# **Attachment C**

**Submissions**

**Subject:** Submission - D/2015/966/G - 155 Mitchell Road ERSKINEVILLE NSW 2043 - Attention Jessica Symons

Streets), to increase street wall height to Metters and MacDonald Streets from 5 storeys to 7 storeys, increase the overall height in storeys of the southern building from 7 storeys to 8 storeys and increase the height of roof forms. The concept modification is being assessed concurrently with detailed design proposal D/2023/842.

Approved Stage 1 Concept DA Building Heights

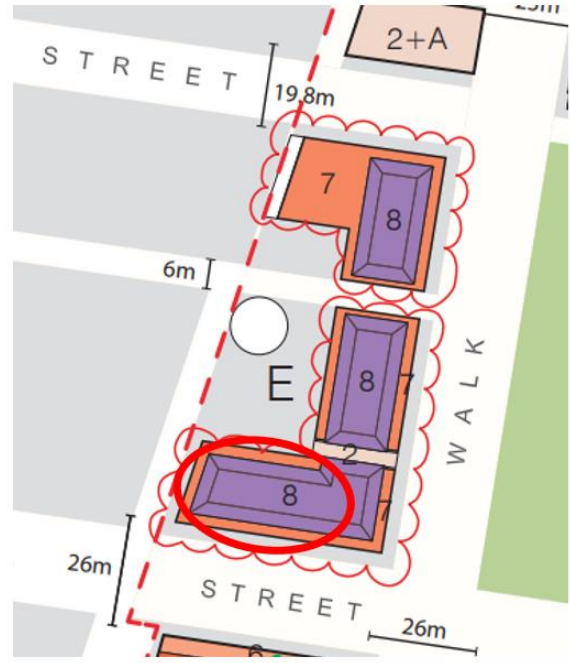
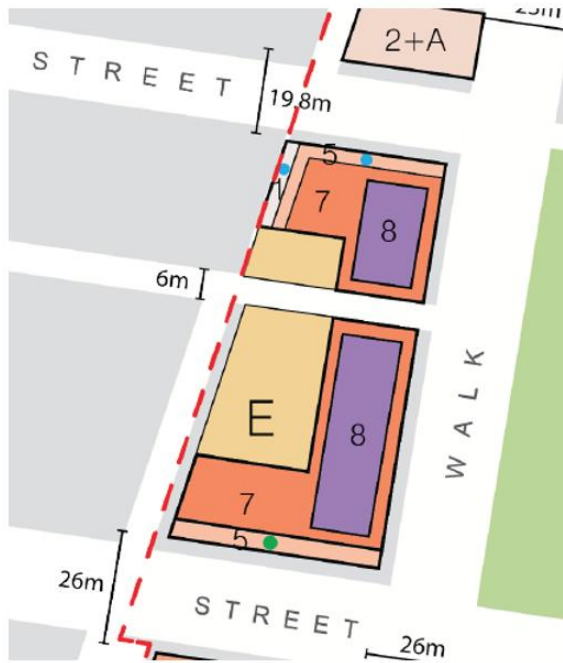
1. **Additional height above the LEP height plane** – We object to the proposed built form intrusion above the LEP height plane.

- Increased overshadowing - The roof feature plant enclosure is above the approved height plane and will create additional overshadowing to the east facing apartments on Casa 1
  - Increased bulk and scale - The pitched “roof feature” is clumsy and out of character with surrounding developments.
  - Visual intrusion - The roof feature is visually intrusive compared to other developments in the area and is out of character with the architecture of the precinct.
  - Reduced outlook from apartments - The roof feature plant enclosure is above the approved height plane and will reduce outlook to the east and south facing apartments in Casa 1
2. Increase extent of 8 storey roof element – We strongly object to the proposed increase of 8 storeys along McDonald Street.

Approved Stage 1 Concept DA Building Heights

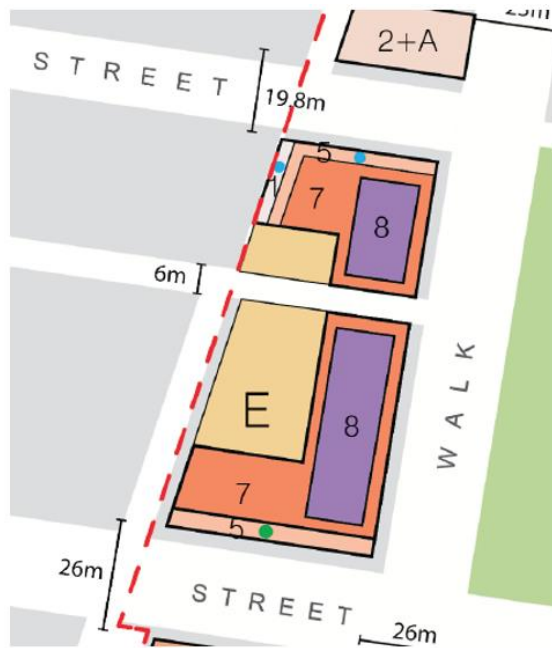
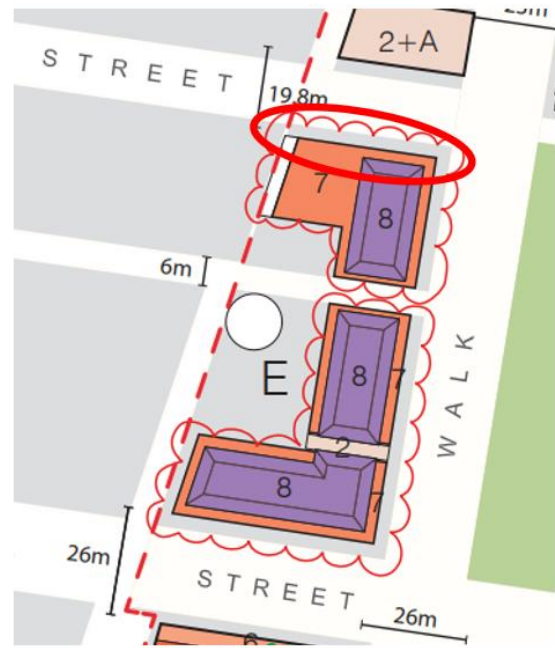
- Increased bulk and scale - The pitched “roof feature” is clumsy and out of character with surrounding developments.
  - Visual intrusion - The roof feature is visually intrusive compared to other developments in the area and is out of character with the architecture of the precinct.
  - Reduced outlook from apartments - The roof feature plant enclosure is above the approved height plane and will reduce outlook to the south-east facing apartments in Casa 1
3. Increased street wall height to Metters Street – We strongly object to the increased street wall height from 5 storeys to 7 storeys.

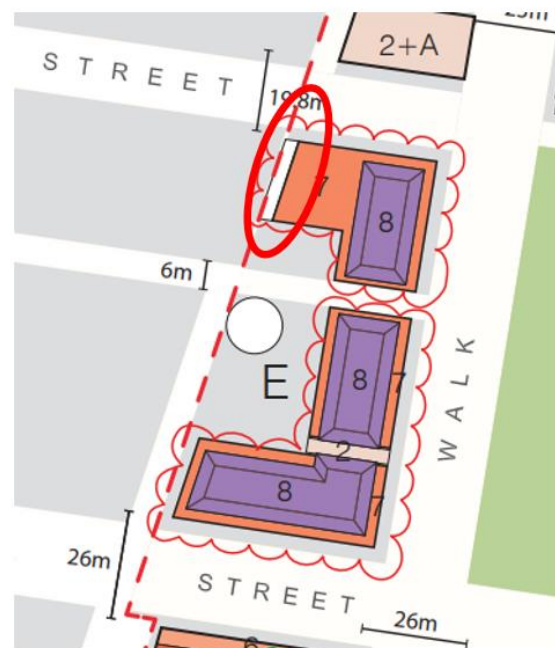
- Impact on character of Metters St – as noted above, Metters St is unique in that it has a consistent 5 storey street wall scale character, with recessed upper levels. The submitted scheme proposes to increase the street wall height to 7 storeys. This will be inconsistent with the rest of Metters Street and detract from the character and human scale established in the wider precinct. The proponent's justification for the increase in street wall height was that buildings in adjacent blocks to the east have higher street wall heights. This has already been recognised through the allowance of 7 storey street wall height to Kooka Walk in the approved stage 1 concept plan. Extending the increased wall height along Metters Street has no urban design justification and will in fact have a negative visual impact on the street.

The only other justification provided by the proponent is that *additional street wall height is the direct result of the pursuit of the additional GFA allowable when a design excellence process is undertaken*. This is not a valid urban design argument and will not contribute to the delivery of design excellence in the precinct. There is no urban design justification for the increase street wall height.
